Check report by Sales + CR after finishing stage IV (Apartments)

Flat No	205	Other		Sl. No.	43059
Company	MRUV LLP	Project	BRUV	Phase	
Prepared by	Venket Reddy	Sign		Date	6/8/24
Project Manager	Sarman	Sign		Date	06-08-24
Stage II report no.					
Checked By MD on		MD Sign		For filling	☐ Yes ☐ No
Recommendation: ☒ Work is satisfactorily completed. Possession may be handed over. ☐ Minor corrections given herein to be completed before handing over possession. ☐ Major corrections required. Do not handover possession. Request for recheck after completion of works. ☐ Works incomplete. Check report cannot be prepared. Request for recheck after completion of works.

Quality Control Check Report. Stage: After Finishing Stage III (Apartments)

BLISS MIDALE Residency @ GENOME VALLEY

Description	Direction	Owners & Developers :	Date :	Promoted by
First Floor Typical Flat - 105,109	 N	Modi Realty (Genuine Valley LLP	Prepared By : Imran	Modi Properties Pvt Ltd
		Project Name & Phase :	Approved By : Soham Modi	
		BKGV	Scale :	N.T.S
				Phone : +91-40-66115551

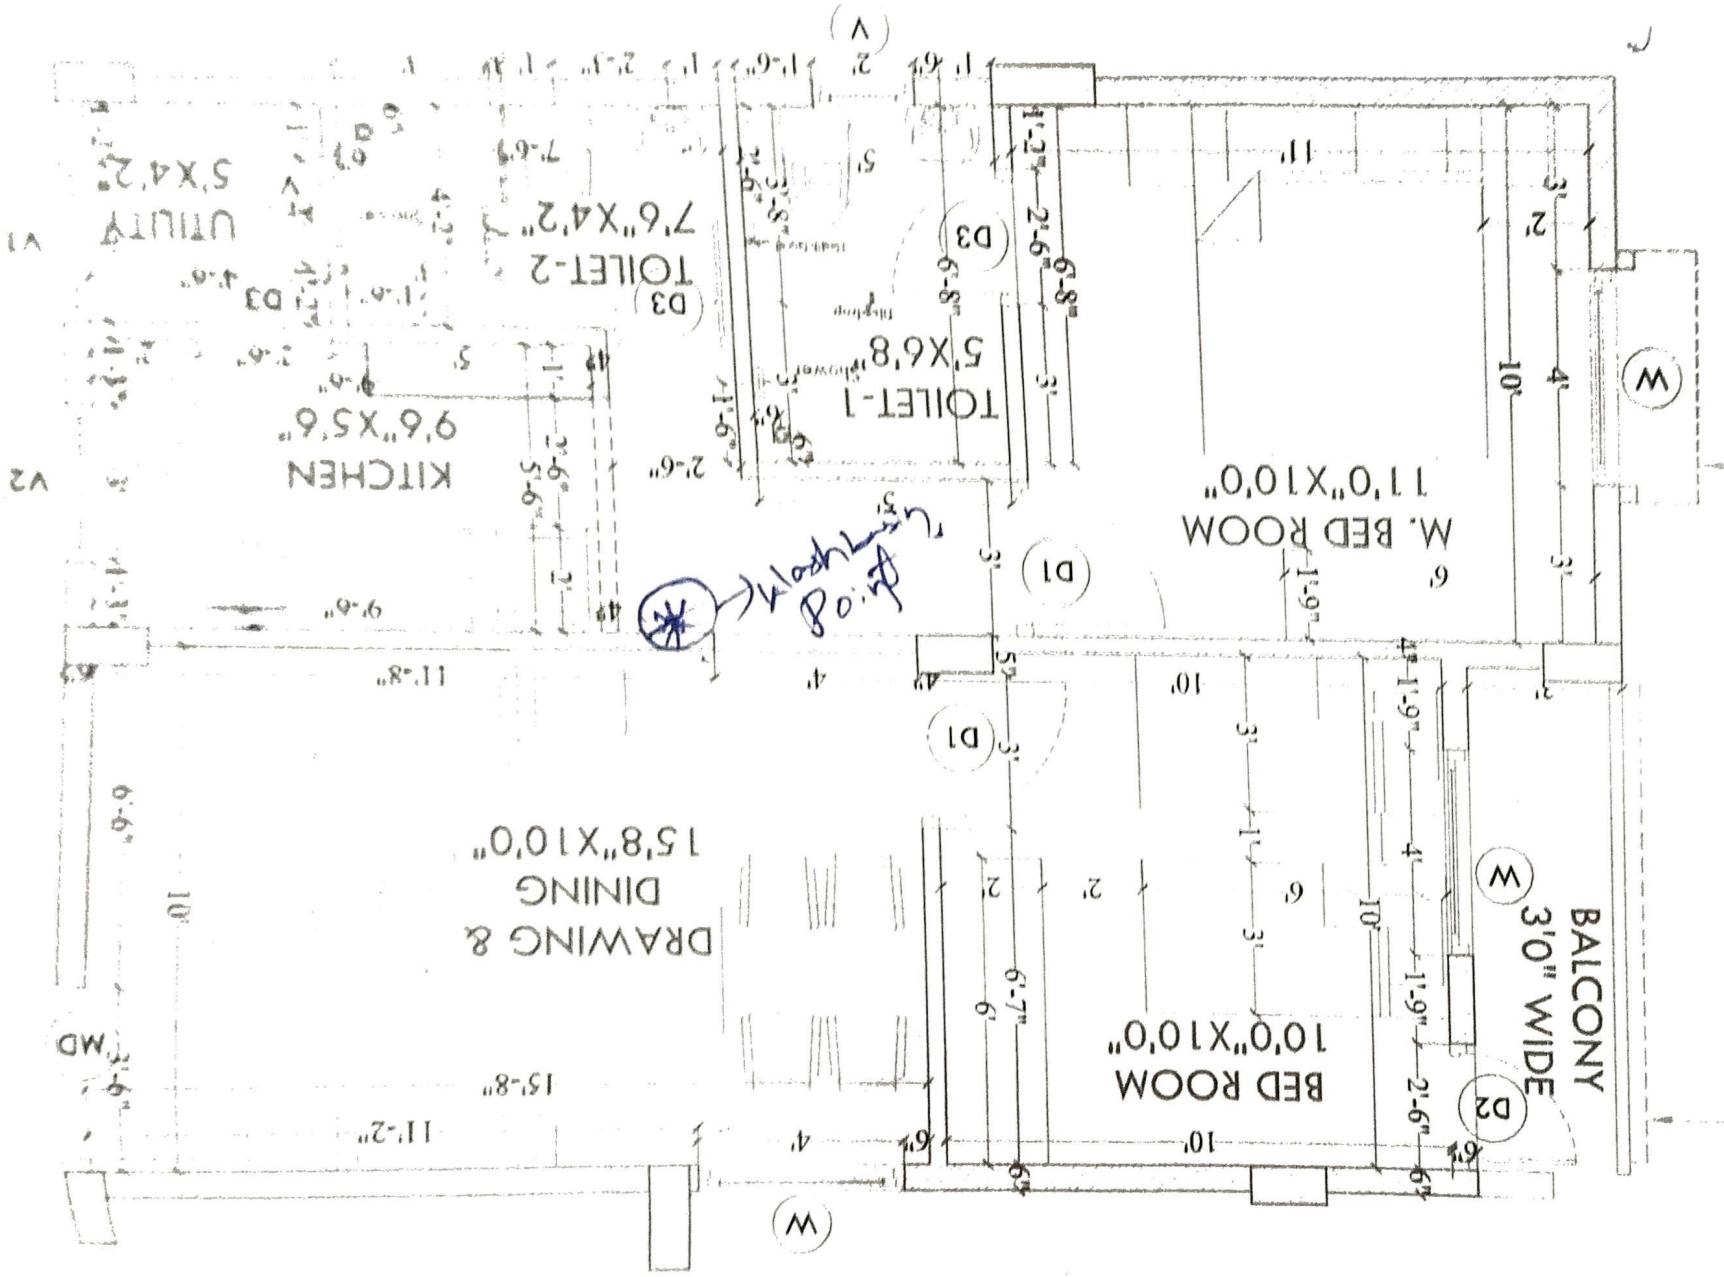
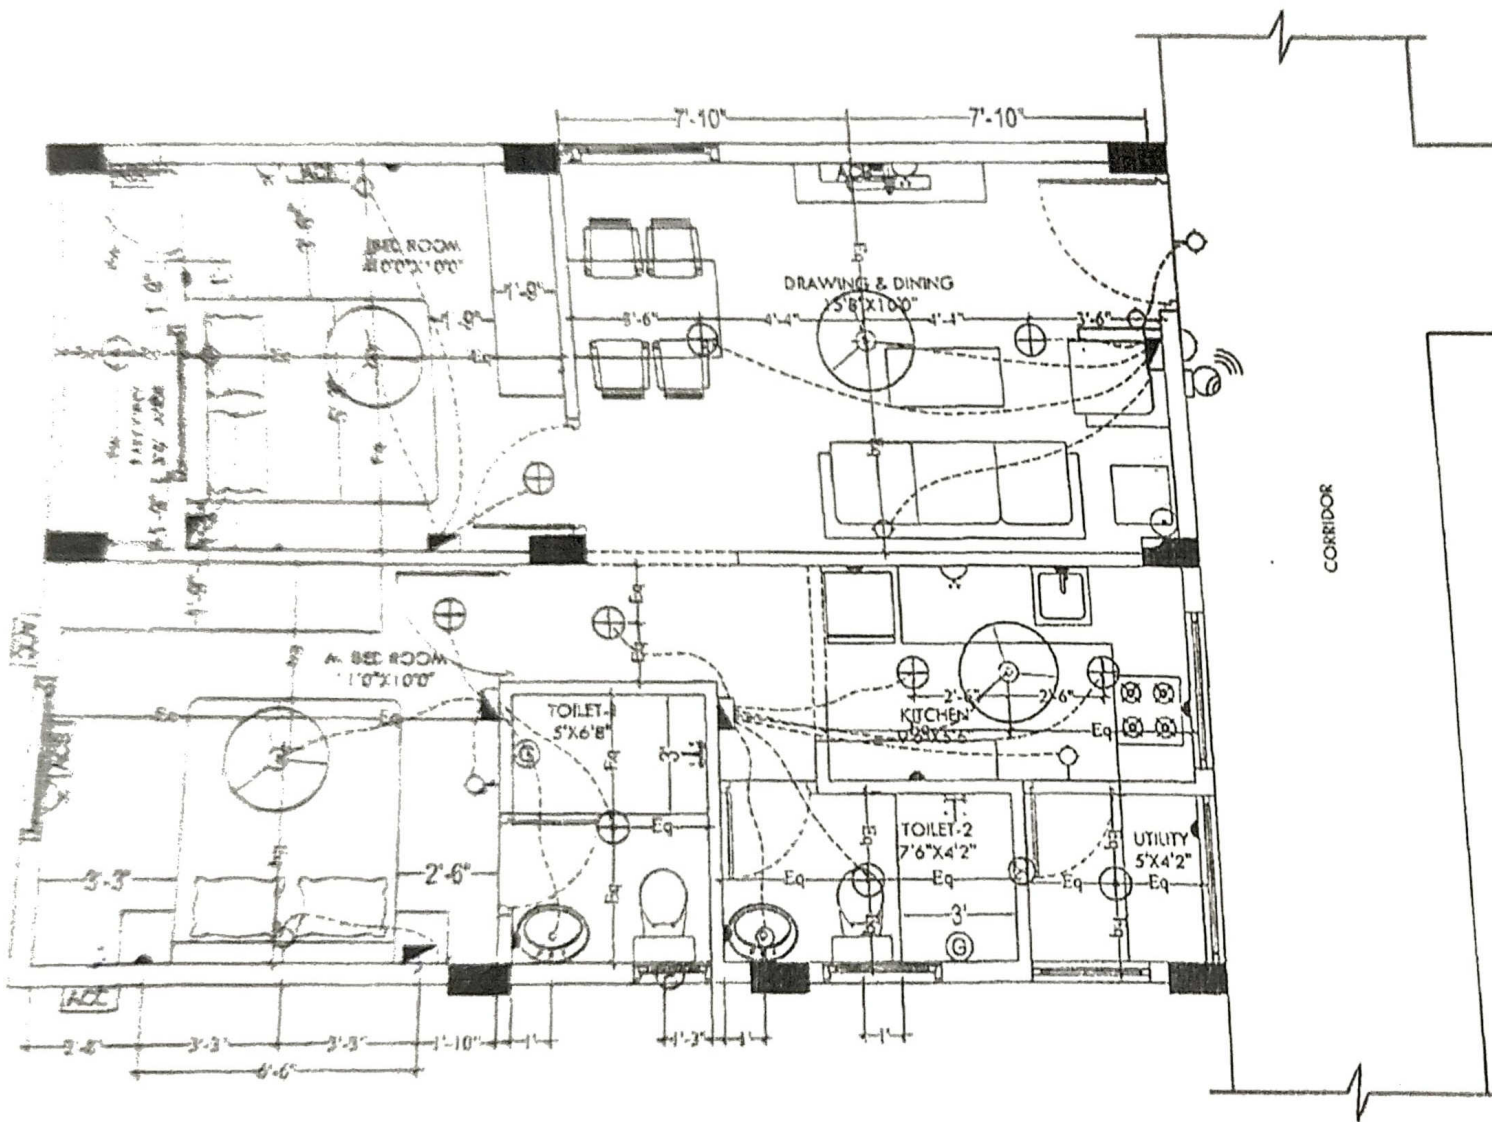
2) Black Lamin. Position hole shifted from 1st window to kitchen

Wall.

- 2) Exhaust hole $\rightarrow$ Kitchen cost ✓
- 3) Bathroom hole $\rightarrow$ Kitchen cost ✓
- 4) Window not visible to customers on 1st fl $\rightarrow$ reduced ✓
- 5) TV Position should be on southern wall of hall ✓
- 6) Colour clarification $\rightarrow$
